TECHNICAL BULLETIN

Front Seat Belt Height Adjuster – Rattles – Repair Procedure

76-92

MODEL Sedan Range with Active Seat Belts DATE 7/94

ILLUSTRATION 1

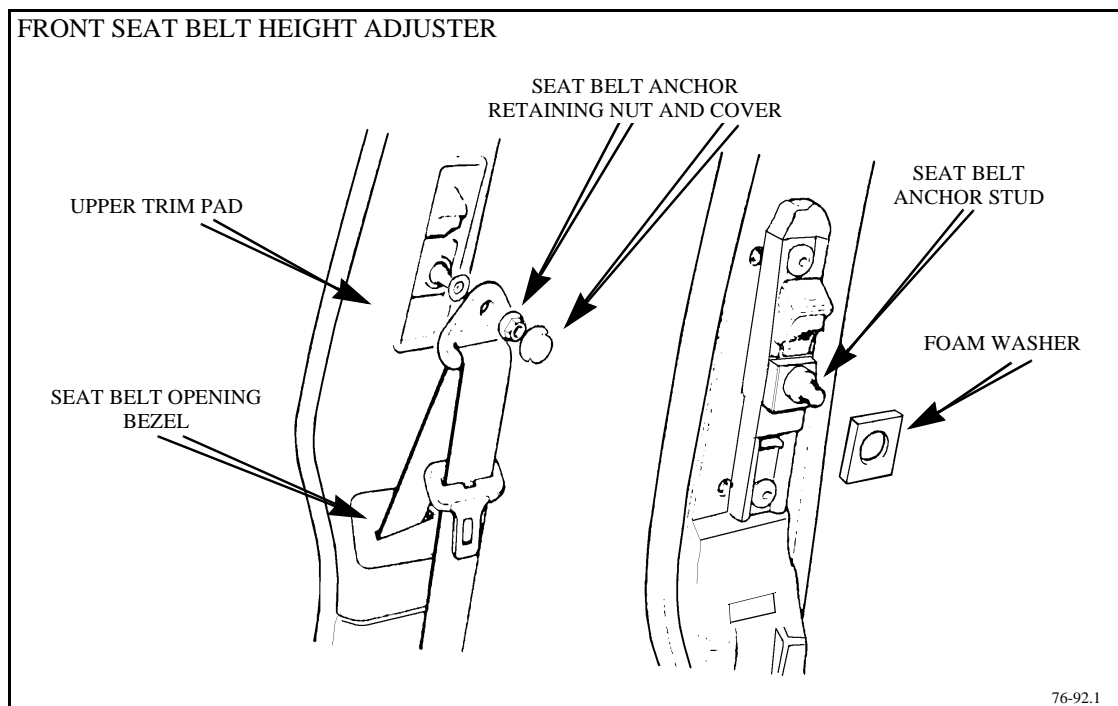
1. Adjust the front seat for maximum clearance to the seat belt height adjuster.
1. Record all customer preset radio stations (including X-mem) and disconnect the negative cable of the battery.
2. Remove the upper seat belt anchor retaining nut cover, retaining nut, and anchor plate. Discard the wavy washer.
3. Remove the seat belt opening bezel. Pull out the door opening edge trim at the bottom of the “B-C” post upper trim pad just enough to clear the upper trim pad clip.
4. Pull the upper trim pad down to release the clips. Then, carefully place it on the seat.
5. Remove the height adjuster trim. It is held in place with an adhesive pad.
6. Remove the paper backing from a new foam washer (P/N KZS 100002) and press the washer over the seat belt anchor stud (Illustration 1).

ILLUSTRATION 2

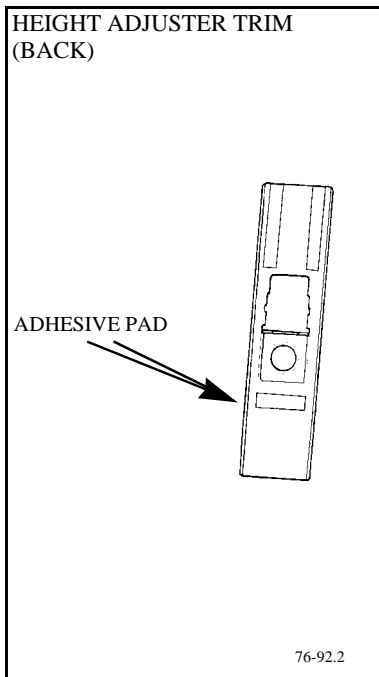
7. Remove the height adjuster adhesive pad (Illustration 2) and replace with a new one (P/N BEC 21458).
8. Reinstall the height adjuster trim after removing the backing paper from the adhesive pad.
9. Install two pieces of anti-squeak tape (P/N JLM 11558) as shown in Illustration 3.
